**Docket Item #10**  
**Development Special Use Permit #2004-0028**  
**6101 & 6125 Stevenson Avenue – Residential**

<b>Application</b>	<b>General Data</b>	
<b>Project Name:</b> Stevenson Avenue	PC Hearing:	April 7, 2009
	CC Hearing:	April 18, 2009
	If approved, DSUP Expiration:	April 18, 2012 (36 months)
	Plan Acreage:	Site A: 39,193 SF (.90 acre) Site B: 46,655 SF (1.07 acres) Total: 85,848 SF (1.97 acres)
<b>Location:</b> 6101 & 6125 Stevenson Avenue	Zone:	Office Commercial –Medium OCM(50)
	Proposed Use:	Residential with existing office
	Dwelling Units:	121 units
	Gross Floor Area:	Residential: 103,696 SF Office: 80,000 SF
<b>Applicant:</b> Steven A. Hansen, LLC and WWIV Stevenson Ave, LLC by M. Catharine Puskar, attorney	Small Area Plan:	Landmark – Van Dorn
	Historic District:	N/A
	Green Building:	Project will achieve a minimum of 26 LEED points

<b>Purpose of Application</b>
The applicant proposes to consolidate two contiguous lots and develop the consolidated parcel as a mixed-use lot by maintaining an existing office building and constructing a 121 unit multi-family building. The applicant requests development special use permit approval to allow an additional 20% of floor

*Figure3: Proposed Site Plan*

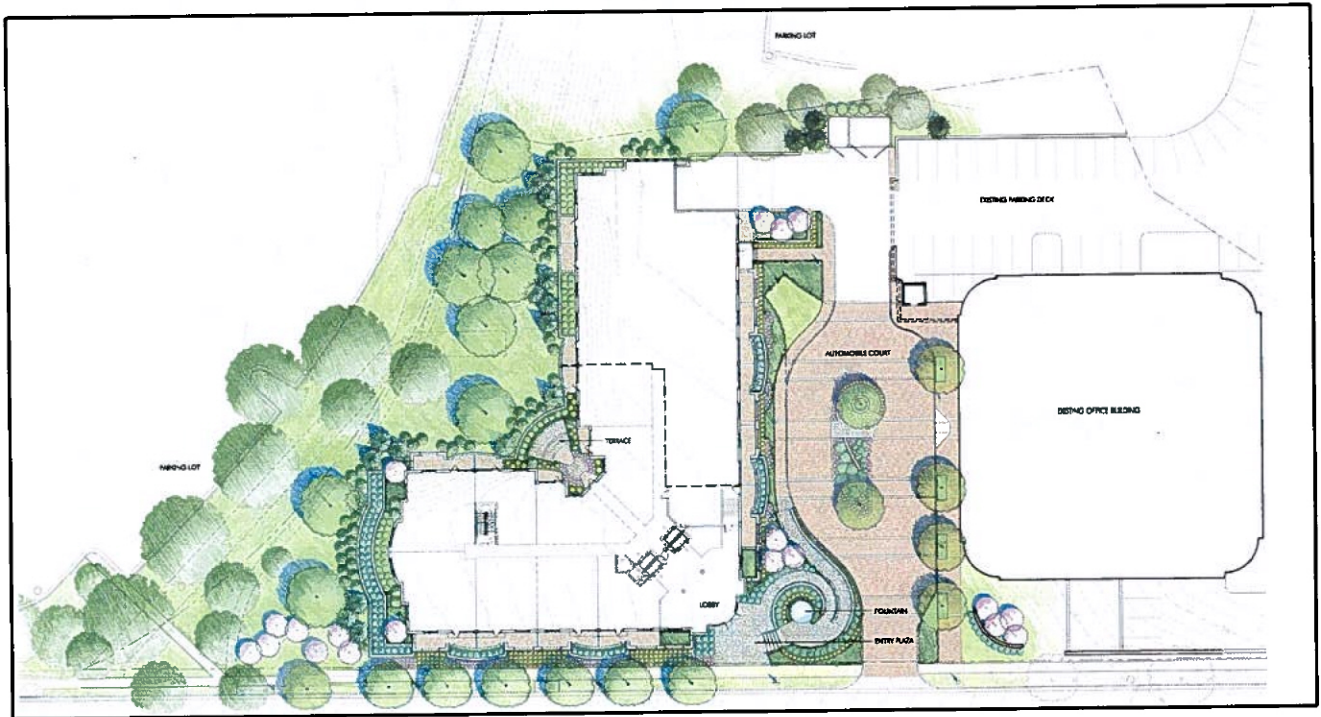
20. The following modifications to the landscape plan and supporting drawings are required:
- a. Replace Stevenson Avenue street trees along property frontage.

- b. Indicate proposed materials to be used in Emergency Turnaround.
  - c. Integrate garage elevator into landscape using appropriate plantings.
  - d. Provide decorative opaque gates for the trash and transformer enclosure. Include details of the gates in the final site plan.

- e. Show tree protection on demolition plan, E&S sheets and grading sheets.
  - f. Coordinate planting details with City of Alexandria Landscape Guidelines. (RP&CA)
